## Lock Up Report

Inspection Date: 29 Jun 2021

Property Address: Niddrie Area

## Non Compliant 2.04

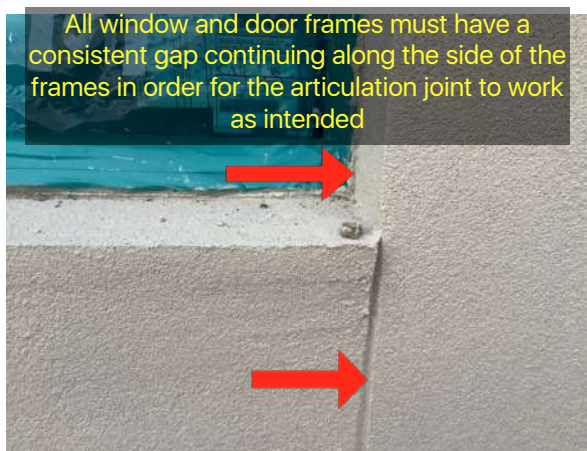
Finding: Articulation joints - Width defective .(AS3700)

To comply with AS3700 all articulation joints must be a minimum gap of 10mm wide and a max gap of 15mm.

The Masonry Structures Code AS3700 limits the amount of movement to be accommodated at a vertical joint to 15mm, and requires that a gap of at least 5mm should remain after the movement has taken place. It limits the amount of movement to be accommodated at a horizontal joint to 10mm.

The joints also must be sealed to maintain the integrity of weatherproofness, acoustic and fire isolation.

## Non Compliant 2.06

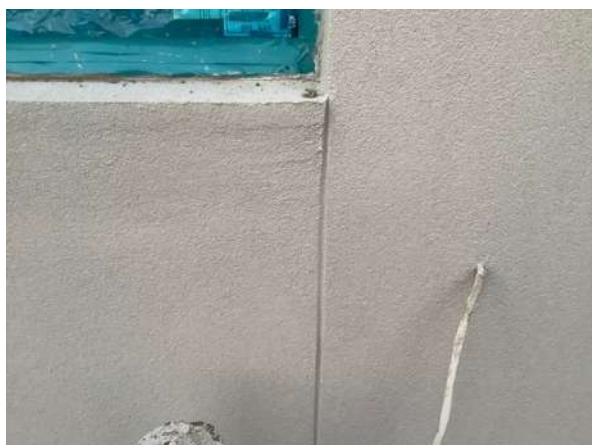
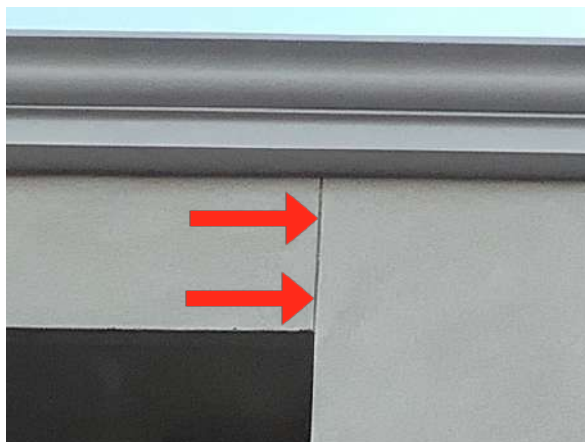
Finding: Articulation Joint - Render Covering Joint - Defective

-----  
-----  
It was observed that render or other similar applied finishes are covering articulation and control joints this is considered a defect with reference to Standards and Tolerances.

All render must be taken out of the control joints and must be caulked with a suitable exterior

sealant that is UV rated.

NO paint or render is to go over the sealant to the articulation joints.

## Non Compliant 2.07

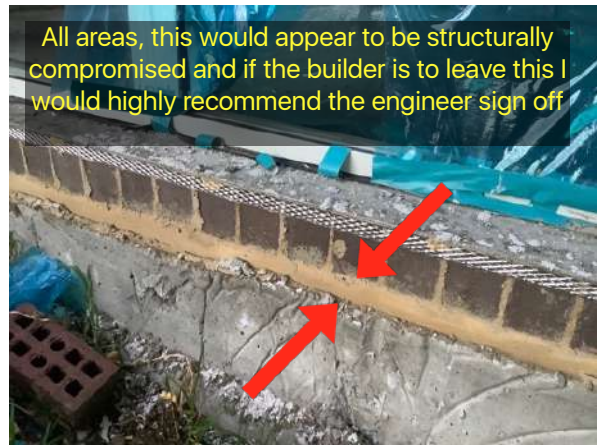
Finding: Brick Base bed joints (concealed) - defective

It was observed that the concealed base bed joint is defective. Concealed base bed joints in masonry walls are considered to be defective if they exceed 40mm in thickness which is the allowable Standards and Tolerances.

## Non Compliant 2.08

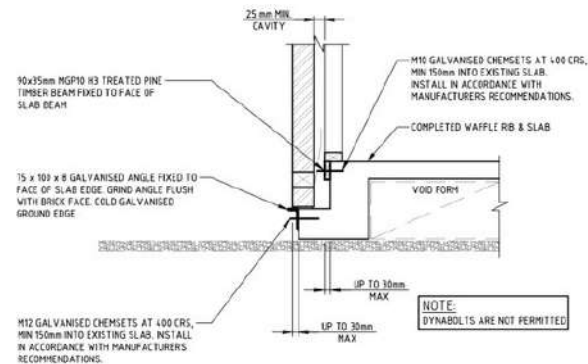
Location: Brick Work - Exterior Perimeter Of Building  
 Finding: Brick/Wall Overhang On Slab.

At the time of the inspection it was found that the brickwork is overhanging the slab by more than 15 mm.

Standards and Tolerances 2015 - Diagram 4.08 states that the maximum overhang of the brick work is 15 mm.

## Non Compliant 2.09

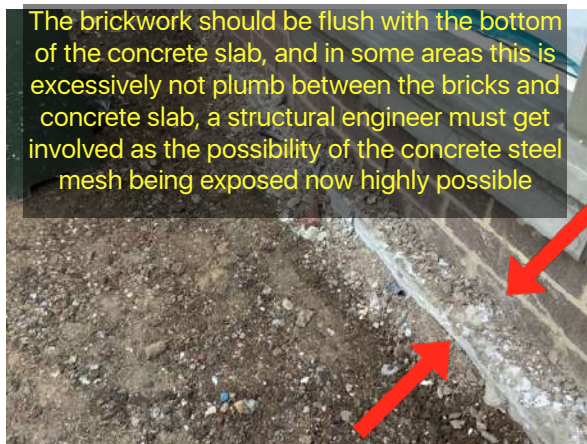
Finding: Bricks Base - Overhang Of Slab.

It was observed that there are MANY areas where the edge of the slab protrudes past the document finished dimension of the slab.

The current overhang will affect any concrete pavement or hard material landscaping such as pavers and as such the overhang needs to be cut back.

The edges of the slab needs to be trimmed back in line with the brickwork face edge. It appears the boxing on the slab may have bulged out which occurs when insufficient pegging and bracing is provided prior to the concrete pour and/or simply just mis measurements of the timber boxing.

It is very important that if cutting the concrete slab back, which appears to be the method that will have to be taken, the vapour barrier will more than likely be damaged and compromised . The builder must repair all the vapour barrier if it gets compromised in any way. Once the builder cuts all the excessive slab around the perimeter of the building , The vapour barrier more than likely will get damaged. So in order for the vapour barrier to comply and provide the job that it is intended to do, I HIGHLY RECOMMEND that the builders dig the perimeter carefully,, sometimes the entire perimeter, pending of the severity of the vapour barrier (plastic) damage, pending on slab over pour, pending on excessive builders concrete (debris). It is important to dig along the slab perimeter without damaging the plastic and to extend the vapour barrier plastic higher than the slab rebate as would have been in the post slab report if we performed one.

## Non Compliant 2.10

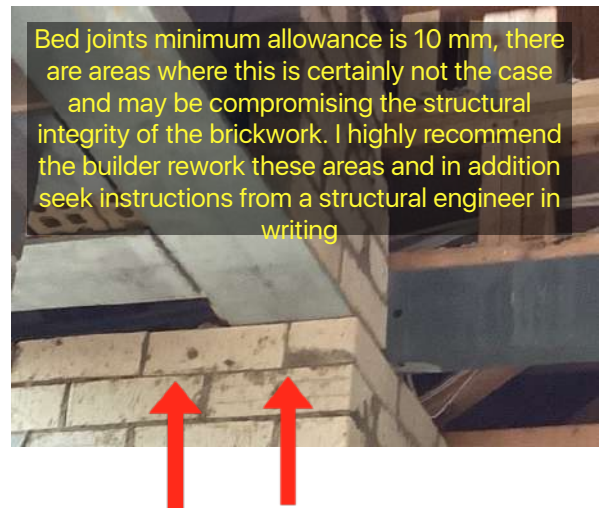
Finding: Brick Bed Joint - Deviation of bed joint thickness

It is observed that there is an excessive deviation from the documented thickness of the bed joint.

There are variations in excess of 10mm which is excessively highly then the acceptable levels of workmanship regardless if it is the bricklayers defective workmanship and/or defective sizing or seconds brick supplied by the builder.

The maximum non-structural framework tolerance is 3mm. This identified defect exceeds the maximum allowable tolerance and is therefore considered a defect.

Generally the remedial works are demolition of brick work and/or at the clients consent render.

## Non Compliant 2.11

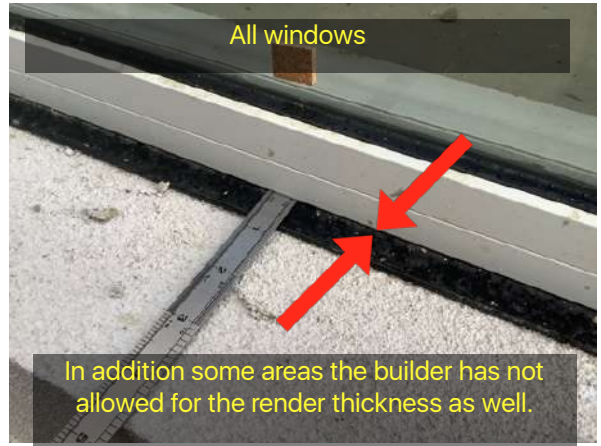
Finding: Insufficient-Gap between window and brick sill.

A 5mm to 8 mm gap ( pending on situation ) between the window and the brick sill is required as a minimum as without the gap the glass can break under pressure and the window can bow and/or jam not allowing the window to open at all.

The windows should all be re-worked that do not have the gap.

The base of the window frame must be reworked to allow a gap for shrinkage. I refer the builder to the BCA, part 3.3.1.10,

## Non Compliant 2.12

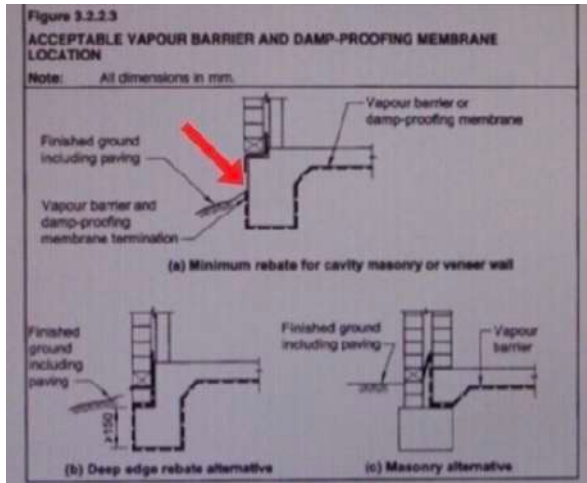
Finding: Vapour barrier - Defective (AS2870- 2011)

The builder has not completed the vapour barrier system to the porch area and the alfresco area concrete perimeter. These areas require the exact same requirements for a vapour barrier system without compromise as the slab of the main building area.

It was noted at the time of inspection that a vapour barrier had not been installed in accordance with AS2870 and BCA Part 3.2.2.6.

To entirely dig the external perimeter of the building at least 300mm below the vapour barrier system (black plastic) damaged areas, which will vary in areas and then overlap the existing plastic with the new plastic by a minimum of 200mm and taped.

The overall height of the plastic must be above the top of the slab rebate surface for now at construction stage.

The plastic must be hard against the concrete with no soil, rocks and/or builders debris in between the slab and the plastic.

Any over pour of concrete must be cut flush and include engineers report for alteration works and if steel is visually seen must now also be notified to the structural engineer to determine the remedial works.

## Non Compliant 2.13

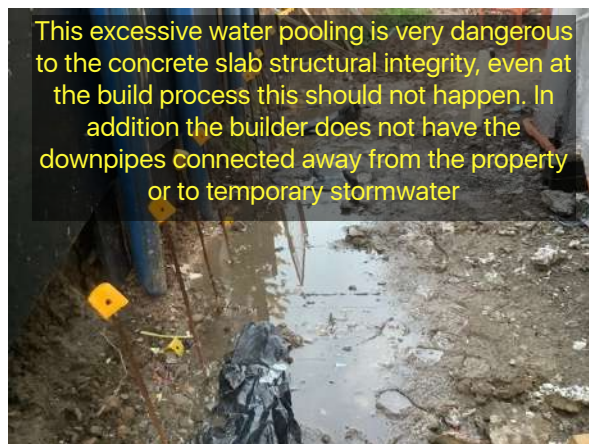
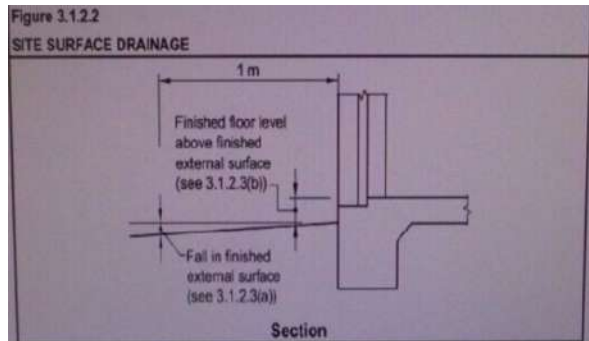
Finding: Drainage - Fall Ground Perimeter Building - Inadequate Fall (AS2870)

At the time of inspection, it was noted that drainage in these areas is poor, and likely to result in the pooling of water around footings and foundations. Slab and footing movement is often caused by a failure to design and construct in accordance with Australian Standards. Such movement is likely to cause major secondary defects in the long-term.

The soil levels around several footings need to be adjusted to ensure that footings and foundations are protected from excessive moisture.

To be compliant, finished ground levels (FGLs) must fall away from slab and footing construction by a minimum 50mm over the first 1 metre. This fall is designed to promote site drainage away from foundations to minimise susceptibility to erosion.

## Non Compliant 2.14

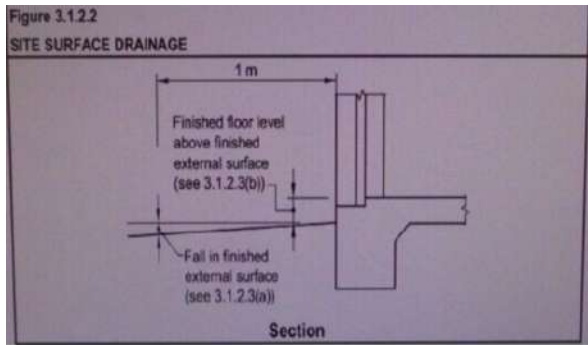
Finding: Site Drainage / Ground Levels High - Owners Responsibility ? Or the builder ?

Whilst I am unaware of the level of works that will be performed prior to handover in relation to drainage, I would like to bring to your attention the slab height is low in relation to the existing land levels and high ground levels is potentially a VERY HIGH RISK CONCERN to a concrete slab and it is absolutely imperative that on completion of the home, the client be very aware of who is responsible for the drainage around the entire perimeter of the concrete slab, is it the builder ? if the builder has provided the garden or perimeter concrete or is it the client ? It is also important to note that just a concrete perimeter of approximately 1 m around the slab even if the concrete has the correct falls is not always enough drainage to protect a concrete slab gaining excessive moisture and/or water ingress.

## Non Compliant 2.16

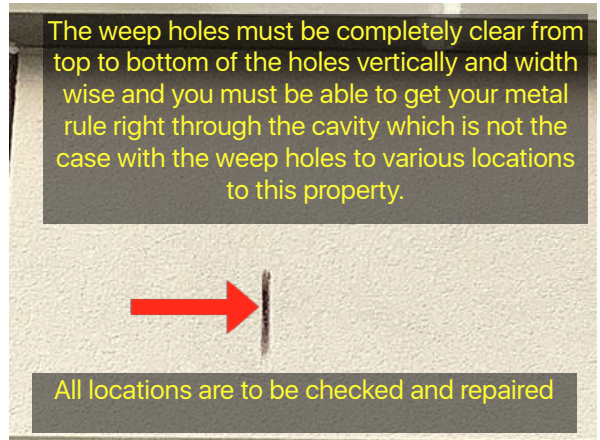
Finding: Weep holes blocked - Brickwork

The weep holes to the brickwork are particularly blocked. Weep holes are designed to allow water to escape the cavity from leaks or seepages in brickwork before the water enters in or damages the wall cavity and in particular to windows and doorways. Weep holes should be kept clean and free of debris or blockages.

It does appear that the renderers have used excessive render internally of the weep holes.

The weep holes must be completely clear from top to bottom of the holes vertically and width wise and you must be able to get your metal rule right through the cavity which is not the case with the weep holes to various locations to this property.

## Substandard Workmanship 3.01

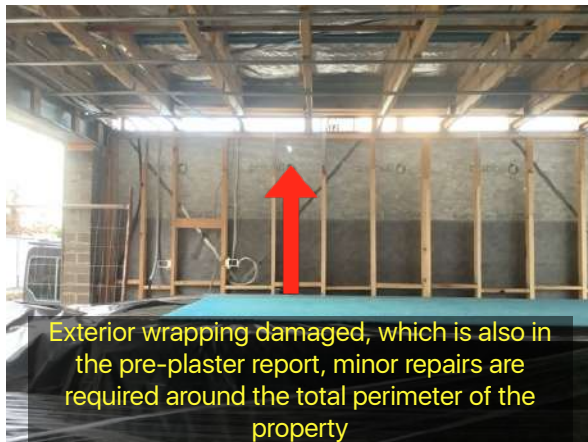
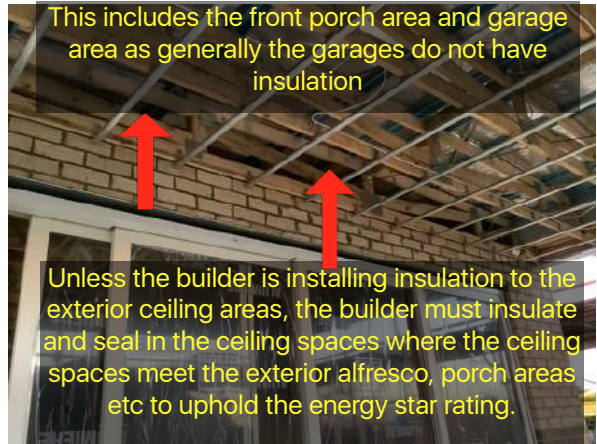
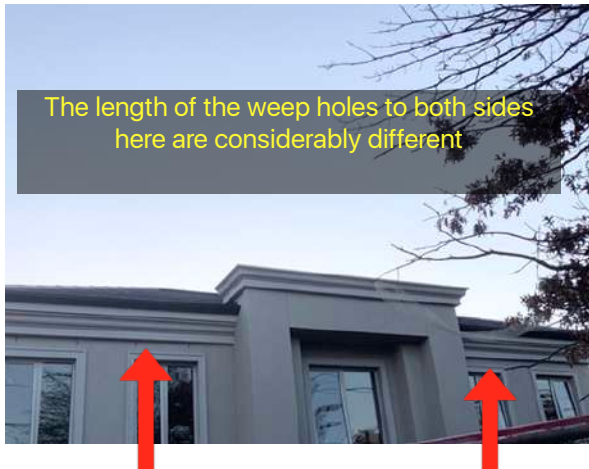
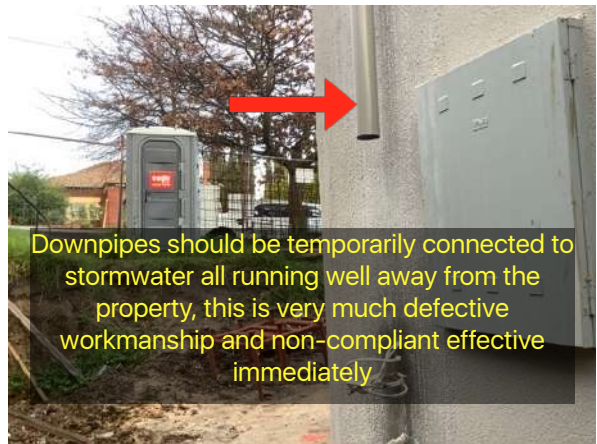
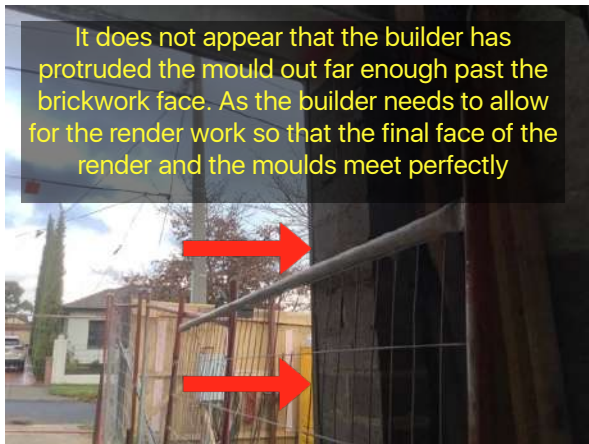
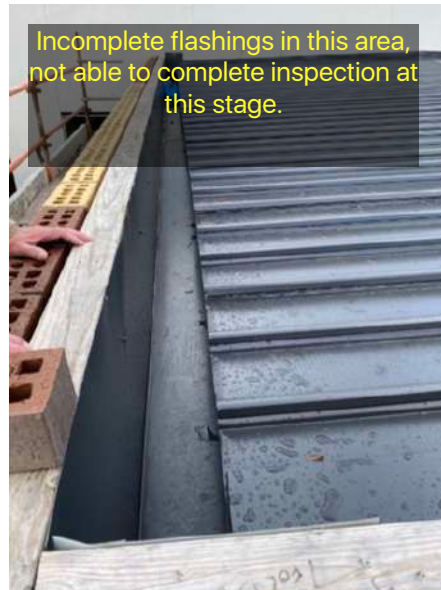
Finding: Unfinished/Defective Works

All these photos are added, to demonstrate DEFECTIVE / SUB STANDARD and/or INCOMPLETE WORKS and they are all required to be rectified as they are ALL not satisfactory for New construction specifications of finish required as per the DOMESTIC BUILDING CONTRACT ACT 1995 as stated in the contract :
